**City Planning Commission Meeting – April 14, 2015**

**CONSIDERATION – SUBDIVISION DOCKET 017/15**

**Applicants: Doka Investments, LLC**

**RESUBDIVISION OF  
LOT 21 INTO LOTS 21A & 21B  
SQUARE 651  
FIRST DISTRICT  
ORLEANS PARISH, LA**

**Figure 1.** Existing encroachments on Proposed Lots 21A & 21B

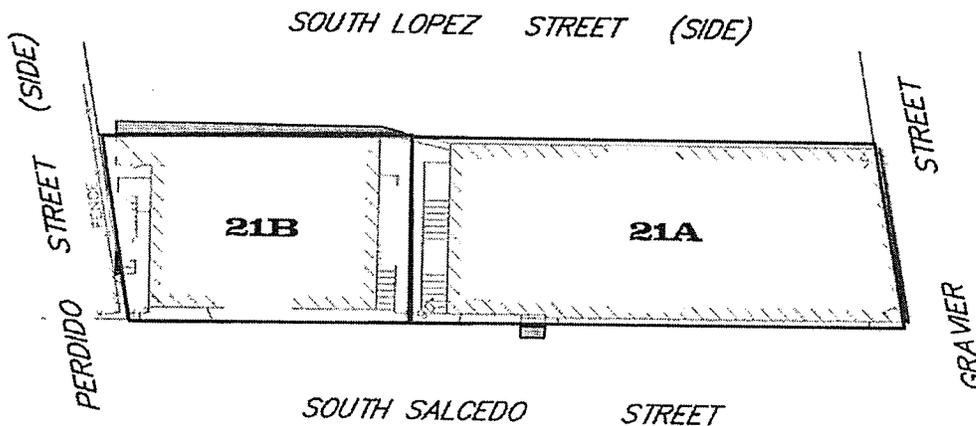
Both existing buildings on the proposed lots have portions of their structures projecting beyond their lot lines. The four-family structure on proposed Lot 21A projects into the Gravier Street right-of-way between 4.74 and 6.74 inches and a set of stairs leading to one of the building's units extends two feet into the South Salcedo Street right-of-way. The three-family structure located on proposed Lot 21B projects 1.74 feet into the neighboring interior lot and one of the building's exterior staircases projects 1.6 inches into a neighboring property.

These projections are existing conditions of current Lot 21. The proposed division of Lot 21 into two lots does not lessen or exacerbate the amount by which the existing buildings extend beyond the property lines.

**Figure 2.** Sanborn maps of subject property

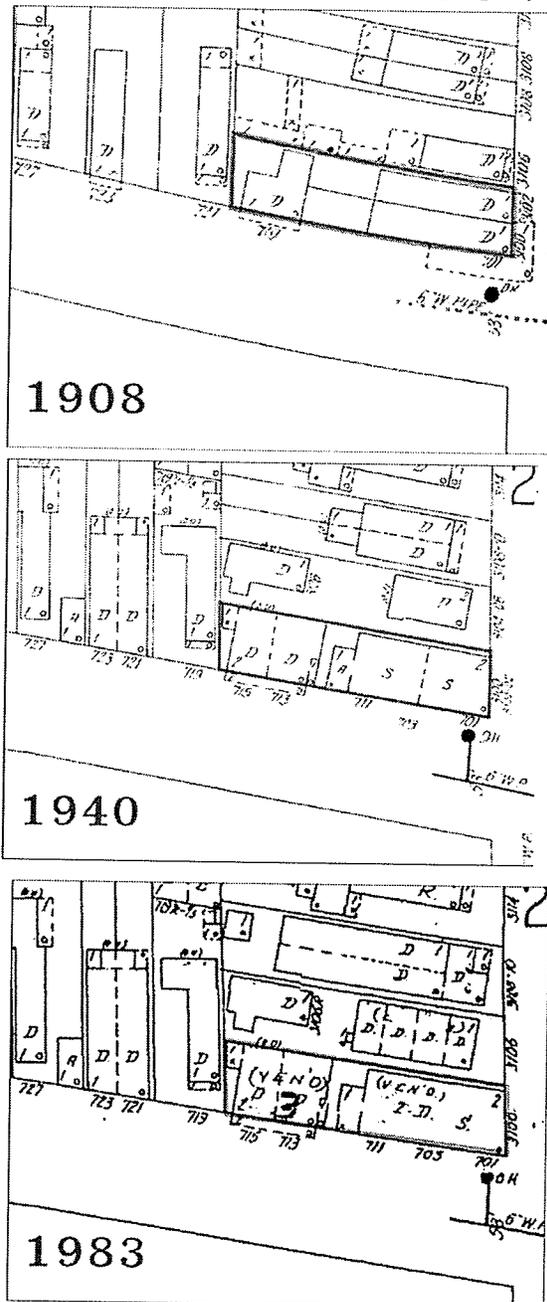
The applicant submitted records from the Sewerage and Water Board that show that water and sewer connections were installed at 713-715 South Salcedo Street and 3100 Gravier Street between 1909 and 1912. Staff examined Sanborn maps from 1908, 1940, and 1983 to confirm that building footprints around this time are consistent with the buildings currently on the property (Figure 2).

The historic maps show the transformation this property has undergone over the last century. The 1908 maps show the property was once divided into multiple lots with three dwellings within the boundaries of current Lot 21. The building footprint is very similar for the building occupying the corner of South Salcedo and Gravier Streets. The dwelling that is shown as 719

South Salcedo Street appears to be what is now 713 -715 South Salcedo Street and is drawn as an L shaped dwelling. This varies from the current building footprint but not enough to conclude that this is not the present day structure. The 1940 Sanborn map shows the building footprints begin to expand to what is shown on the current survey. The major changes from 1908 to 1940 is the erasure of the interior lot line, the conversion of the two dwellings to two shops, the addition of a garage, and the expansion of the building in the rear of the property into two dwellings. The buildings do not

drastically change from 1940 to 1983, but the corner building does convert its space from two shops to one shop and two dwellings. Also important to note is that the maps show that sometime between 1940 and 1983 both buildings were given brick veneers, which explains their current exterior appearance.

There is significant proof that these buildings have been on the petitioned site since 1929 including water and sewerage connection records and maps illustrating the buildings' transformation over time.

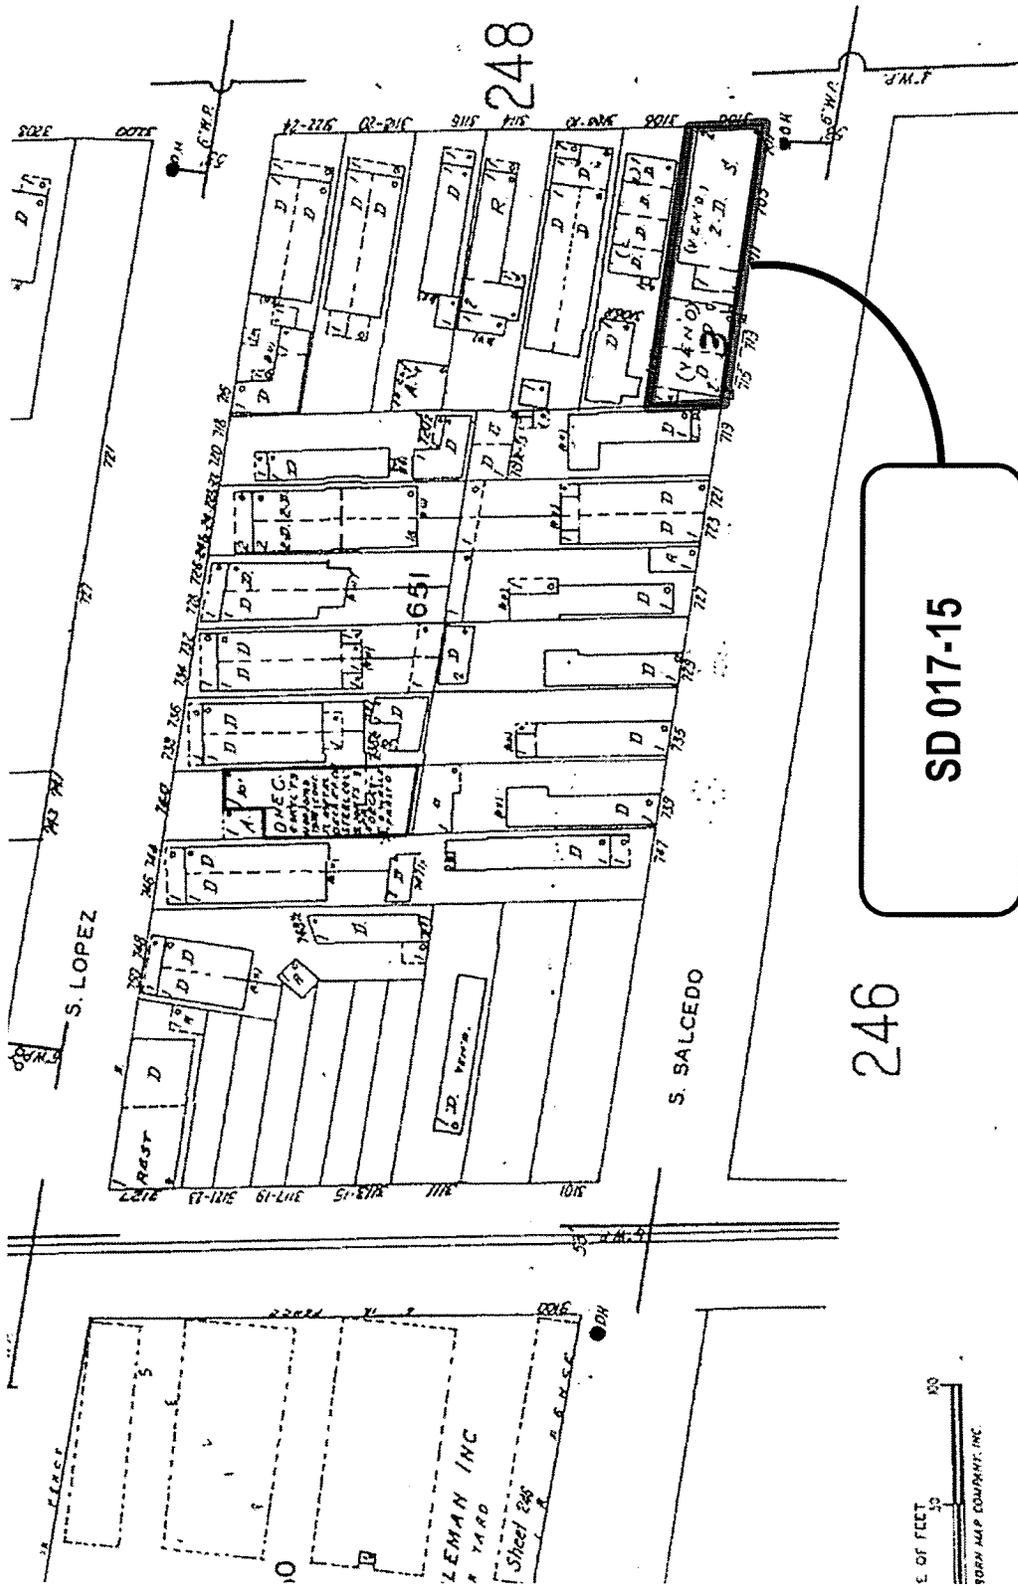
Proposed Lot 21A does not meet any of the lot requirements for single- or two-family residences and meets the area and width requirements for townhouses. Similarly, proposed Lot 21B does not meet the area or depth requirements for the permitted uses in the RD-3 district, but does meet the width requirement for single- and two-family residences, and townhouses. Since the applicant is proposing to create two lots with insufficient depth and area, the applicant will require the following waivers, if approved:

- The applicant shall be granted a waiver of **Article 4, Section 4.6.7 Height, Area and Yard Requirements, Table 4.F Area Regulations for the RD-3 Two-Family Residential District** of the Comprehensive Zoning Ordinance for minimum lot depth on proposed Lots 21A and 21B. Lot 21A shall be allowed a depth of 77 feet along South Salcedo Street, and 71.8 feet in depth along its interior side lot line. Lot 21B shall be allowed a depth of 29.37 feet at its western side lot line, and 28.86 in depth at the side lot line abutting the rear lot line of proposed Lot 21A

- The applicant shall be granted a waiver of **Article 4, Section 4.6.7 Height, Area and Yard Requirements, Table 4.F Area Regulations for the RD-3 Two-Family Residential District** of the Comprehensive Zoning Ordinance for minimum lot area on proposed Lots 21A and 21B to allow a lot area of 2,146.81 square feet and 1,315.8 square feet, respectively.

- The applicant shall be granted a waiver of **Article 4, Section 4.6.7 Height, Area and Yard Requirements, Table 4.F Area Regulations for the RD-3 Two-Family Residential District** for minimum lot width on proposed Lot 21A to allow a lot width of 29.37 feet

The proposed property line between Lot 21A and 21B is located between exterior stairwells leading to the second story of the respective multiple-family dwellings. Currently, there is a gate securing this area with a door for each stairwell. The proposed lot line dividing the multiple-family structures is located two feet from each stairwell. There is no other way Lot 21 could be divided without locating the proposed lot line closer to one building's stairwell than the other. The other side lot lines are existing and are not being moved or erased, so there are no new impacts to those lot lines.

The petitioned property is currently developed with two multiple-family residences, one with three units and one with four units. The applicant is proposing to subdivide existing Lot 21 into two lots so each use will be located on a separate lot of record. Proposed Lot 21A exceeds the minimum lot area of 1,800 square feet by providing 2,146.81 square feet. Proposed Lot 21B has a total of 1,315 square feet, which is 485 square feet (27%) deficient of the 1,800 square foot requirement. The area of proposed Lot 21B cannot be increased within the current boundaries of Lot 21 without decreasing the lot area of proposed Lot 21A and subsequently including a portion of that four-unit multiple-family dwelling. No lots fronting South Lopez, Gravier, or South Salcedo Streets in Square 651 have lot areas below 1,800 square feet. If approved, the staff recommends the following waiver:

Due to the current lot's consistency with the typical lot size and development, and the proposed lot's deficiency in lot dimensions and area, the staff believes the request would unnecessarily create two substandard lots of record. For this reason, the staff recommends denial of this request. If approved, the staff recommends the following three provisos in addition to the waivers already listed in this report:

The staff recommends **DENIAL** of Subdivision Docket 017-15.

1. The request does not meet the criteria for a resubdivision under Policy E as the proposal is an excessive departure from the neighborhood norm and the requirement that the proposed lots have a minimum area of 1,800 square feet.
2. The proposed subdivision is unnecessary and would create two substandard lots of record.
3. The lot configuration in the proposed subdivision is not consistent with the neighborhood norm.

- The applicant shall be granted a waiver of **Article 3, Section 3.2.5.d** of the *Subdivision Regulations* requiring a minimum lot area of 1,800 square feet for Lot 20B.
